RE: Mitcham Gasworks - Amended application submission pack

Response to financial viability information

Planning Application: Proposal

Drainage Layout

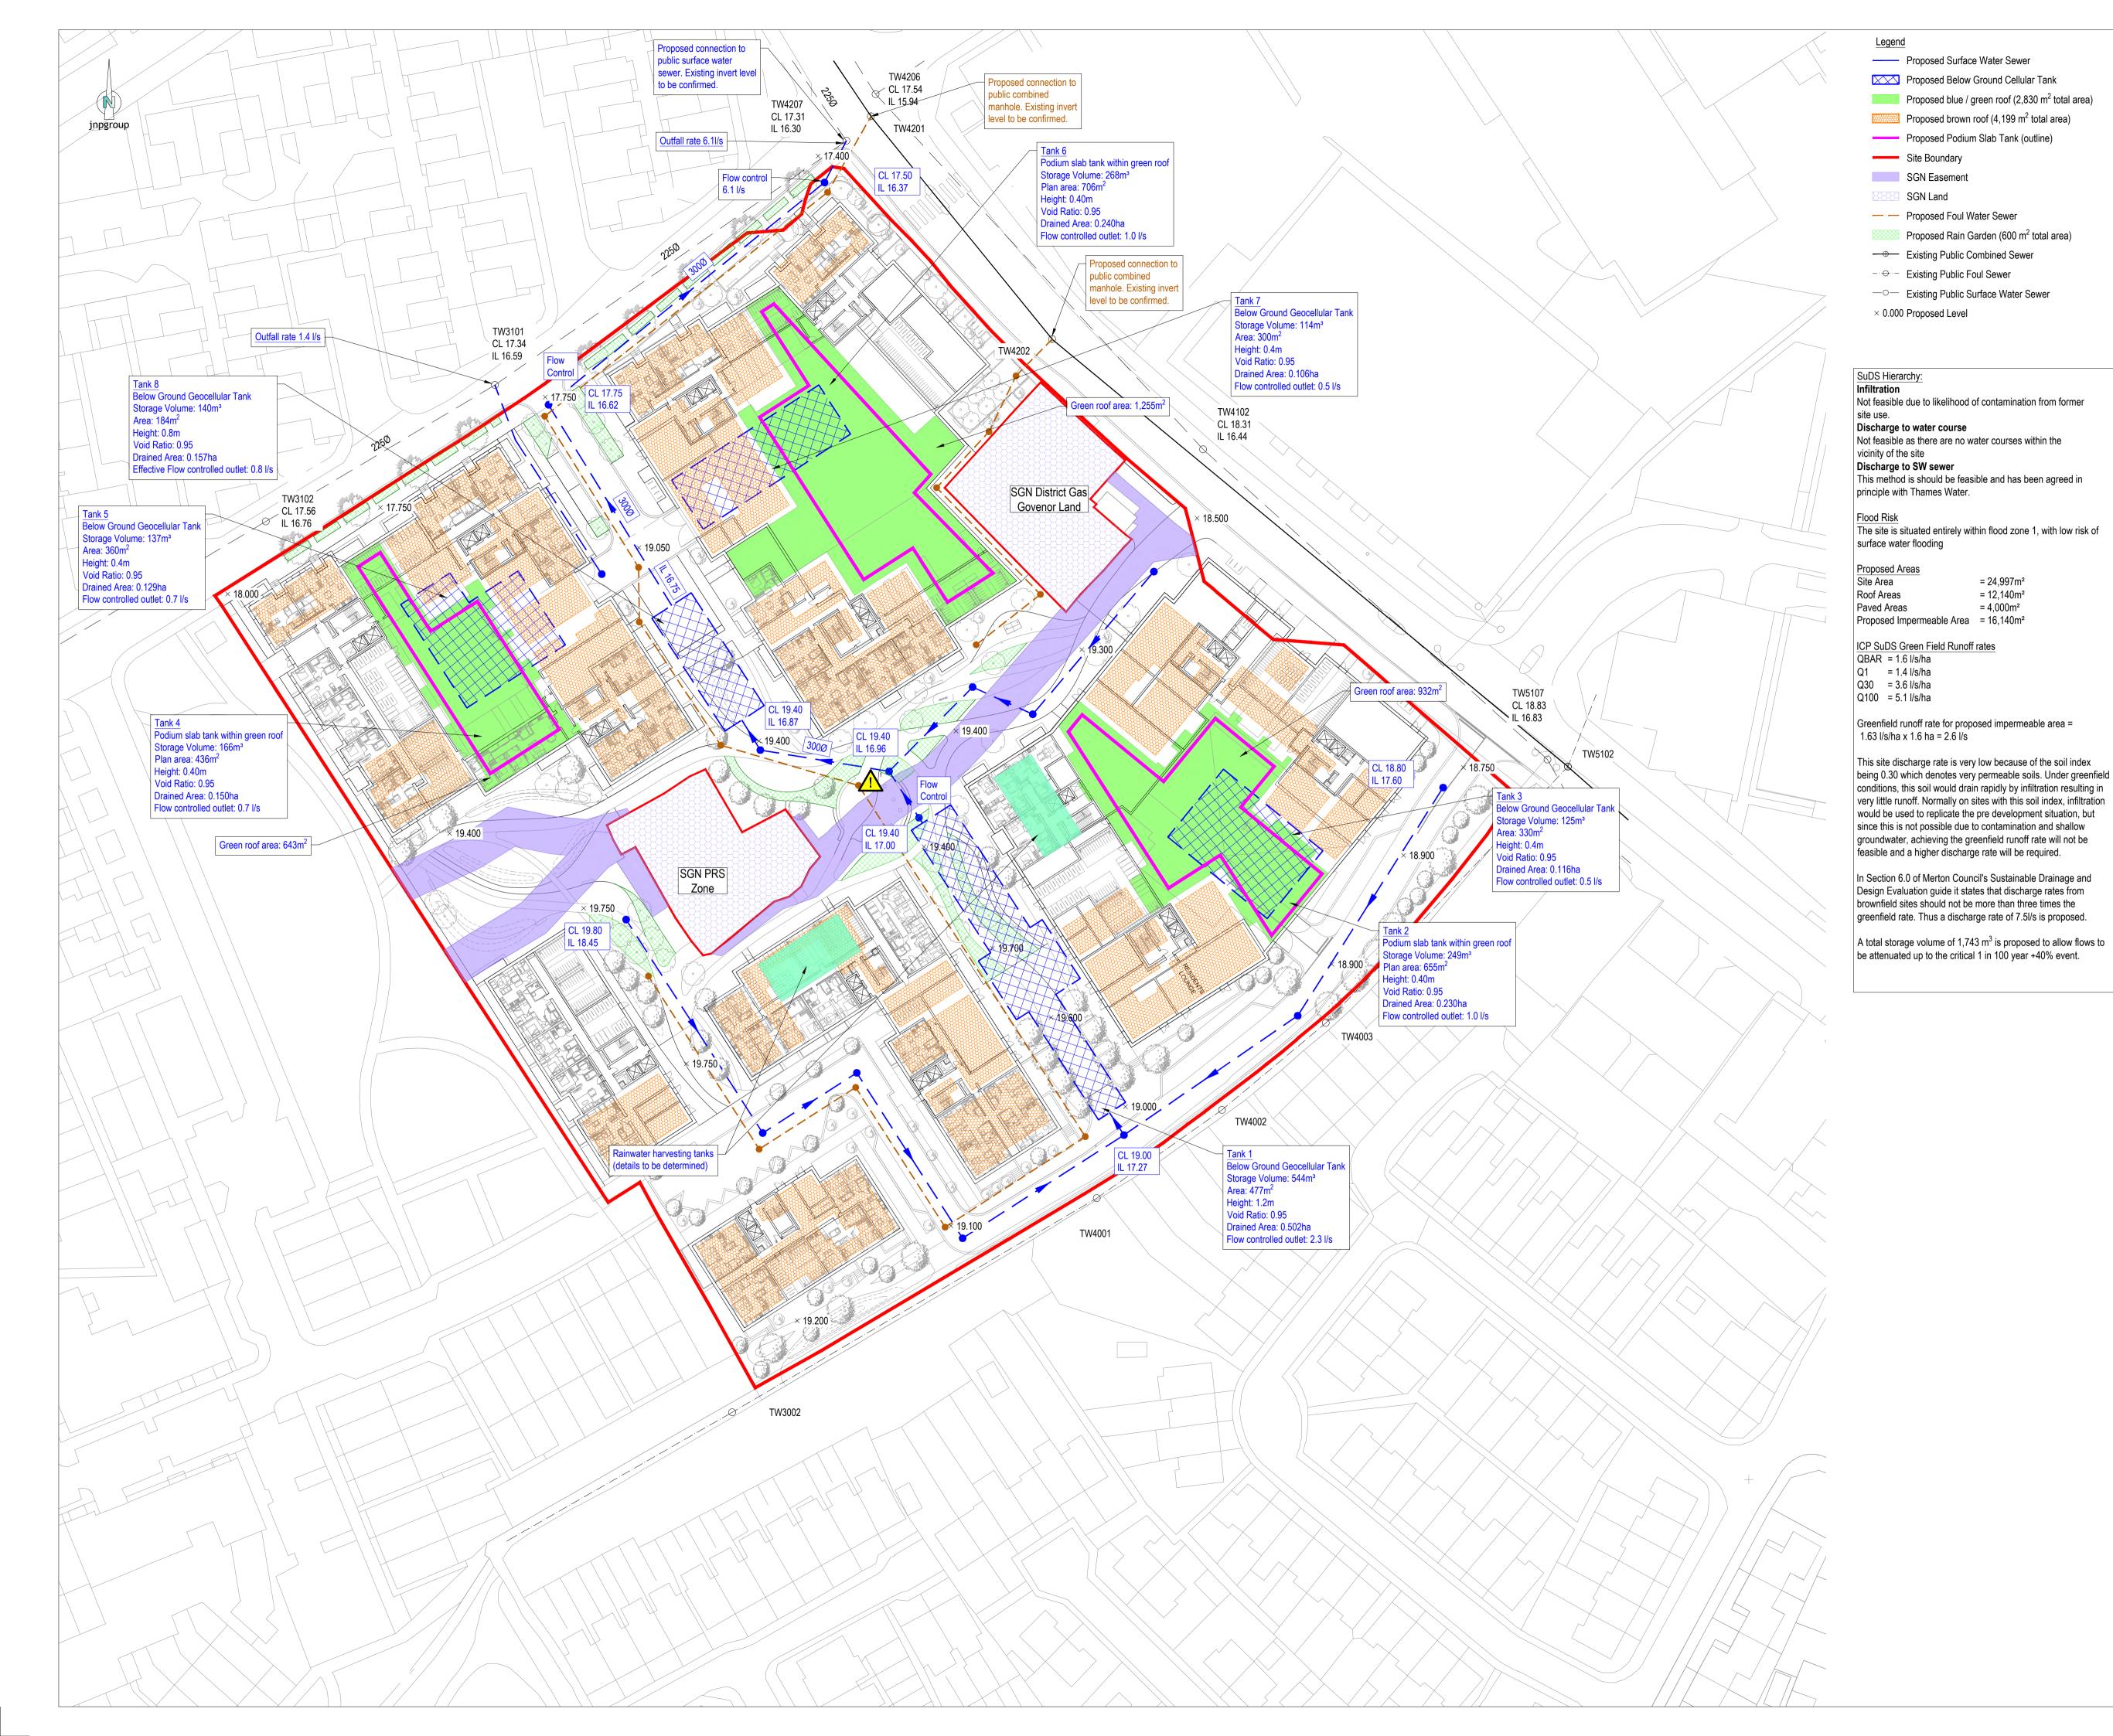
- 4. The location and dimension of all SuDS proposed are clearly shown on the drainage plan provided As Appendix D of the Flood Risk Assessment and Drainage Strategy (BR31002-JNP-XX-XX-RP-C-1000). The plan also includes the rainwater harvesting system, which is supported.

- 4. In terms of SuDS, the drainage strategy proposes green/blue roofs, rain gardens and filter drains, which is welcomed. The location and dimension of all SuDS proposed should be clearly shown on the drainage plan.
